SUNDRY NOTICES AND REPORTS ON WELLS

EOG Resources requests a variance to drill this well using a co-flex line between the BOP and the choke manifold (instead of using a 4" OD steel line).

Co-Flex line
Conditions of Approval

Internal Hydrostatic Test Graph

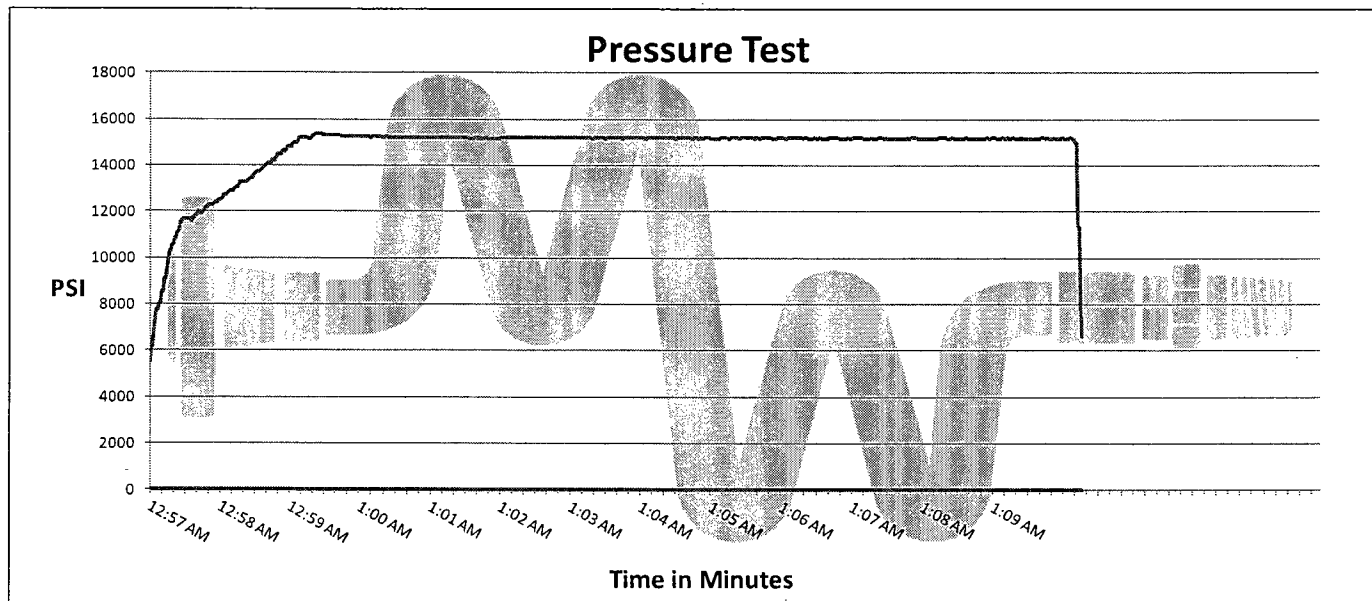
Comments: Hose assembly pressure tested with water at ambient temperature.
